Project No. R.0171363.001

Addendum #003

Tender A – Pleasant Camp Port of Entry

2015-04-22

| RV PAD SITE PLAN AND DETAILS |

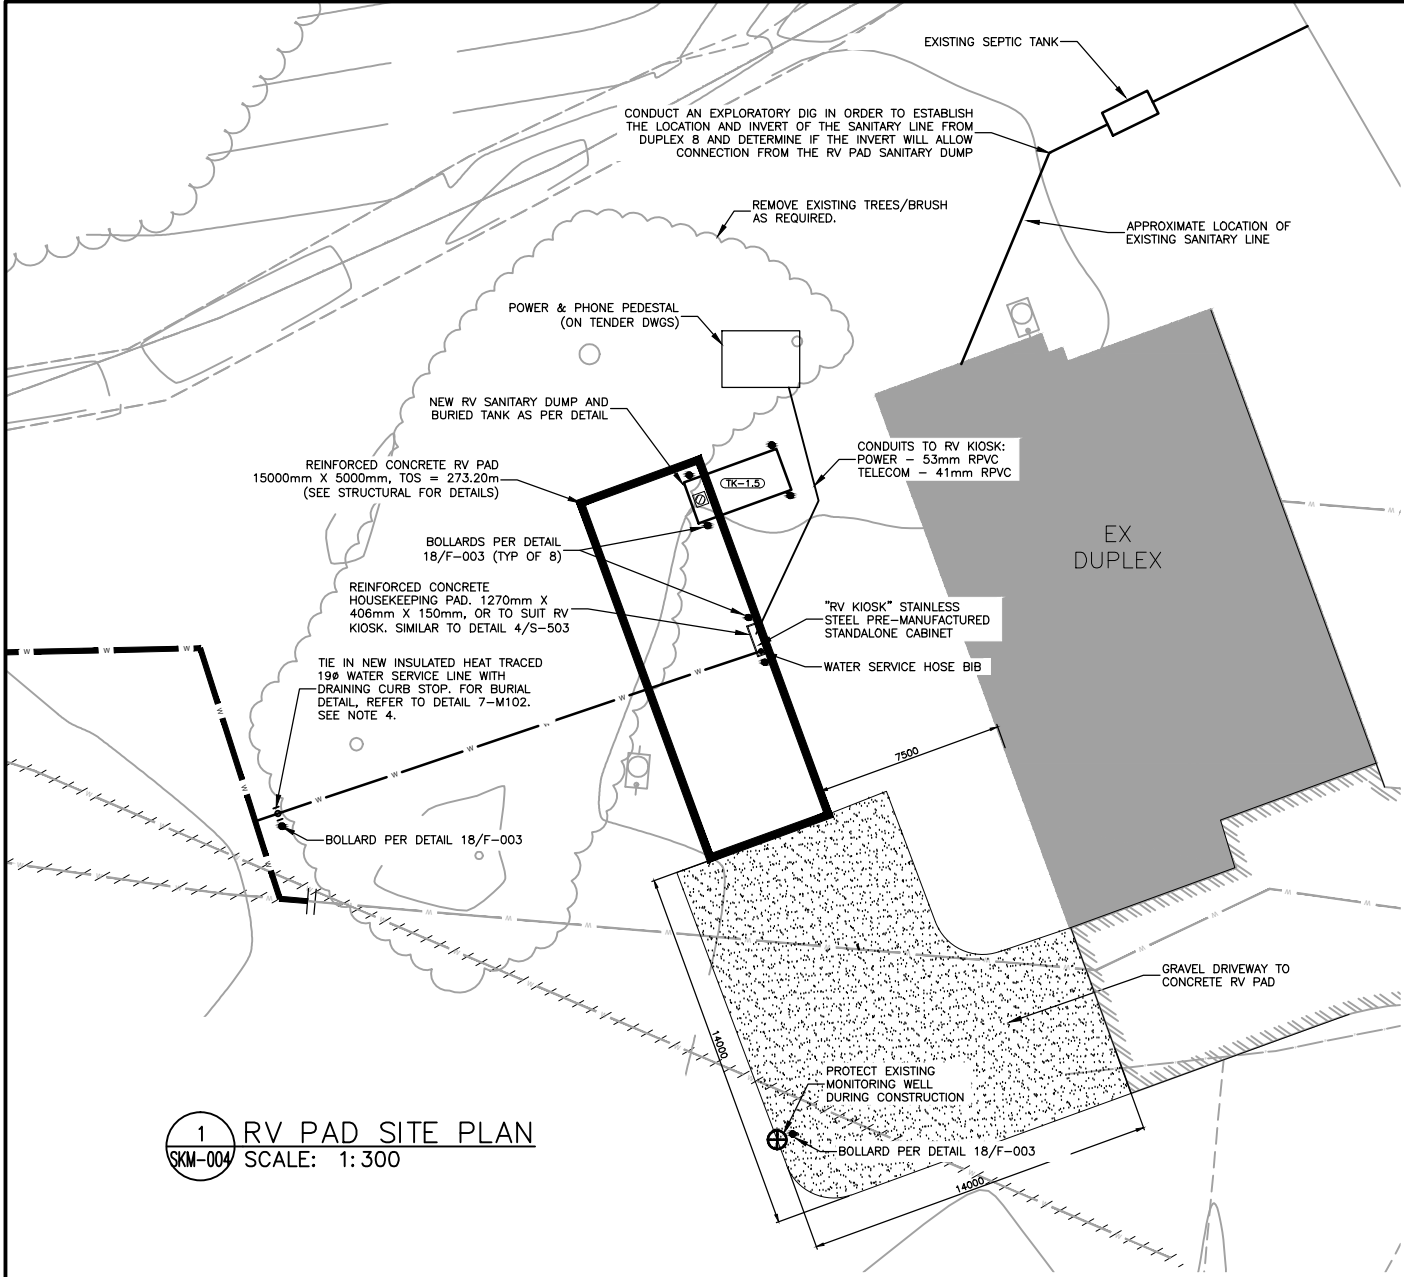
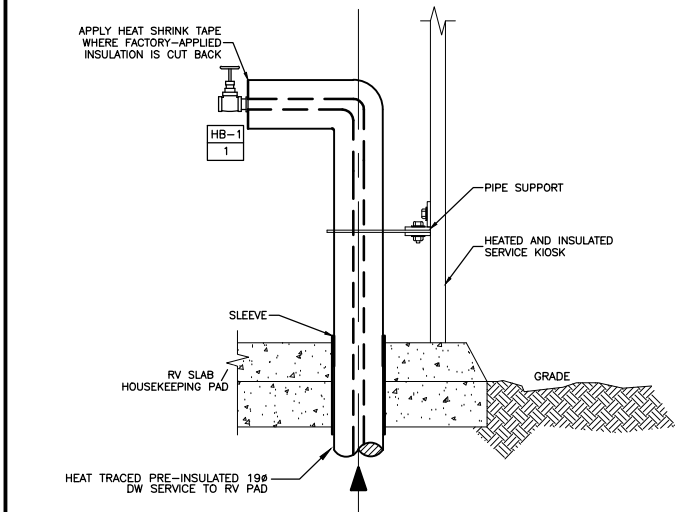
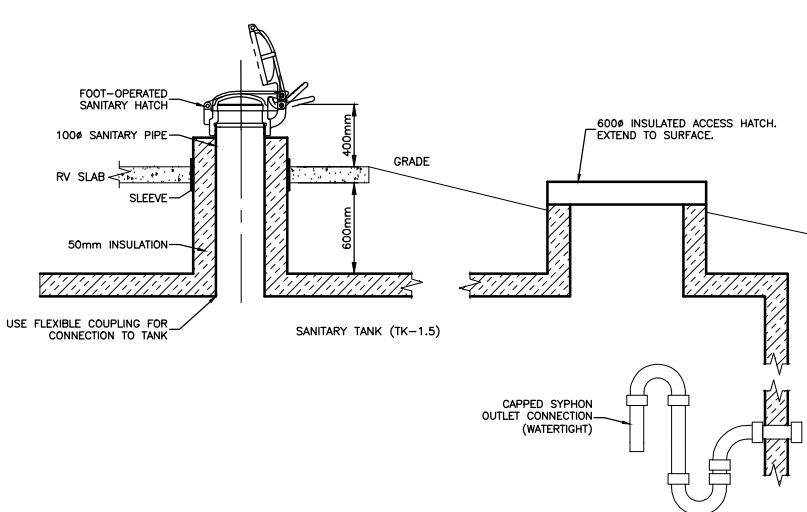
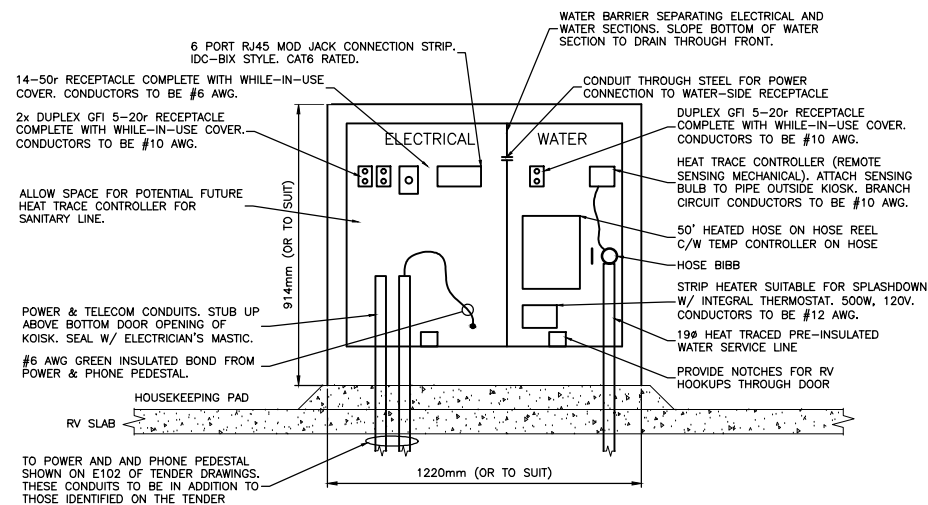
1. Drawing M002, plan 2 (South): add RV pad and services as shown on attached sketch SKM-004 including:
 - a. 19mm diameter insulated heat traced RV water service as specified in 22 11 13 Facility Water Distribution Piping

- b. Buried septic tank and RV dump as specified herein
 2. Drawing E301: Replace schedule for Panel B with the attached as shown on drawing SKE-401.
 3. Drawing E301: Referring to detail 4/E301, delete breaker in Panel A associated with P-1.1.

7. Add electrical services to proposed new RV Pad as described on attached drawing SKM-004.
 8. Provide power and control electrical services to the proposed new water treatment plant and associated accessories as described on attached drawing SKE-401.

- PARTIAL PLAN. FOR CONTINUATION, SEE M102.
- RV KIOSK TO BE STANDALONE STAINLESS STEEL CABINET INSULATED TO R12. ACCEPTABLE PRODUCT "NEMA ENCLOSURES" AS PER ATTACHED PRODUCT CUT SHEET. CABINET TO INCLUDE FULL DEPTH CENTER DIVIDER AND SLOPED DRAIN PAN ON RIGHT SIDE OF CABINET TO ELIMINATE ANY SPILLAGE. REFER TO DIVISION 26 SPECIFICATIONS FOR ELECTRICAL REQUIREMENTS. CONTRACTOR TO SIZE CABINET TO SUIT.
- WATER SERVICE LINE TO BE HEAT TRACED 19mm HDPE WITH 50mm FACTORY-APPLIED INSULATION. HEAT SHRINK AND FOAM-IN-PLACE ALL JOINTS.
- PROVIDE SELF-REGULATING HEATING CABLE THROUGHOUT LENGTH OF RV PAD WATER SERVICE LINE.
- GRAVEL DRIVEWAY TO BE 20mm ROAD CRUSH, COMPACTED TO 95% SPD, MIN DEPTH OF 200mm. INSTALL IN LIFTS NOT TO EXCEED 200mm. GRADE TO DRAIN ADEQUATELY AND TIE IN TO EXISTING. APPROX VOLUME OF FILL: 50m³.

SKETCH: SKM-05

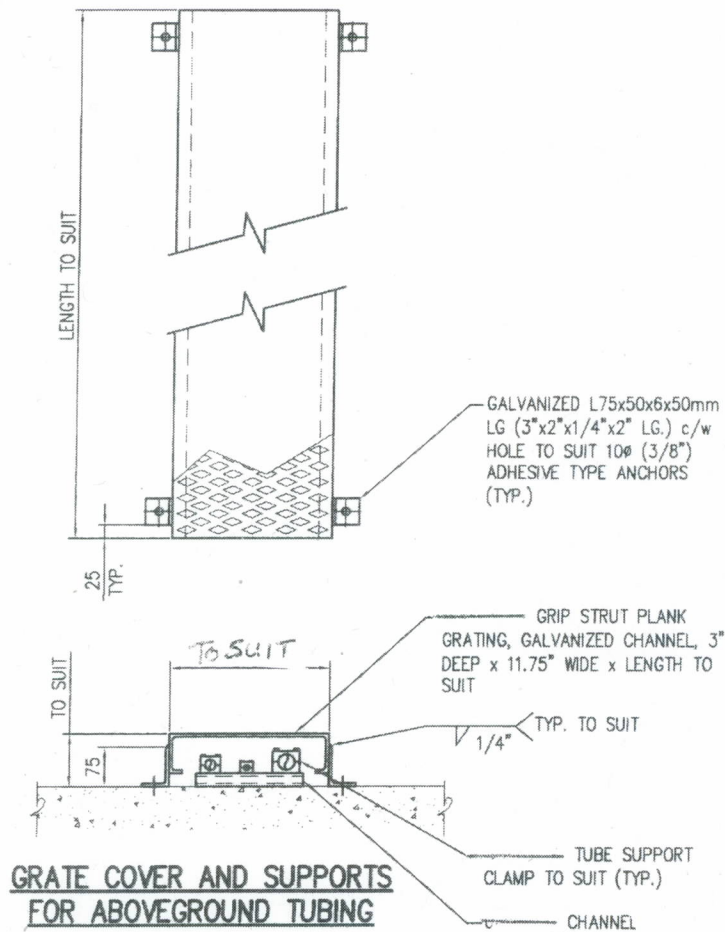
- The portion of the generator fuel supply and return tubing that runs along the floor shall be protected by an expanded metal galvanized steel grating cover with bolting tabs attached to provide clearance for the piping. See attached sketch SKM-005.

1 WTP ELECTRICAL PLAN
SKE-401 SCALE: NTS

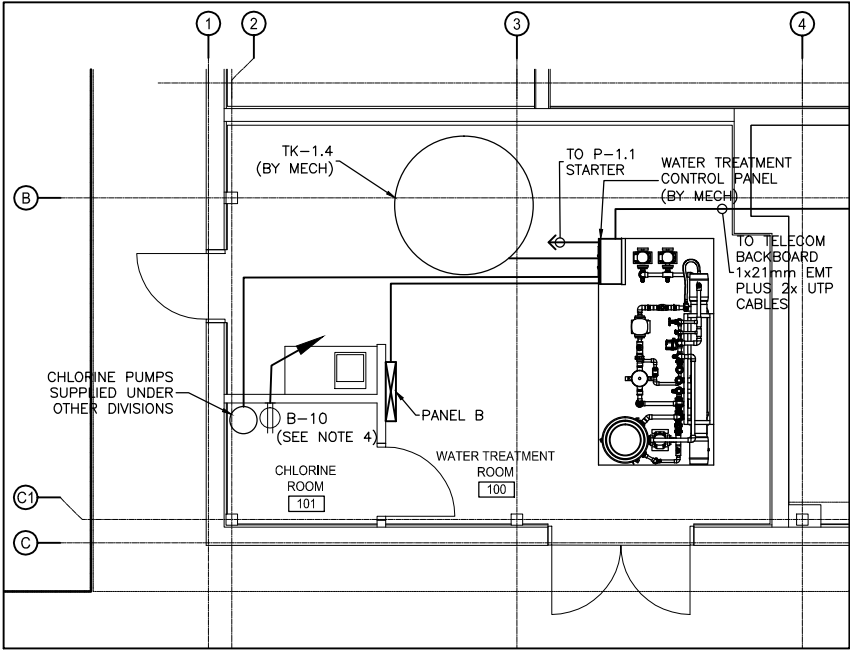
9. Panel K to be as described on attached SKE-401.
 10. Drawing S-001: Add following notes regarding Structural details for new RV pad
Slab on grade for RV:

- NOTES:
- REFER TO TENDER DRAWINGS FOR RECEPTACLE AND LIGHTING LAYOUTS.
 - CONFIRM CONTROL PANEL IS INTERNALLY FUSED PRIOR TO INSTALLATION.
 - REFER TO 2/E401 AND 4/E401 FOR CONDUIT AND CONDUCTOR DETAILS
 - RECEPTACLE TO BE IN CORROSION-PROOF, NON-METALLIC WEATHERPROOF HOUSING
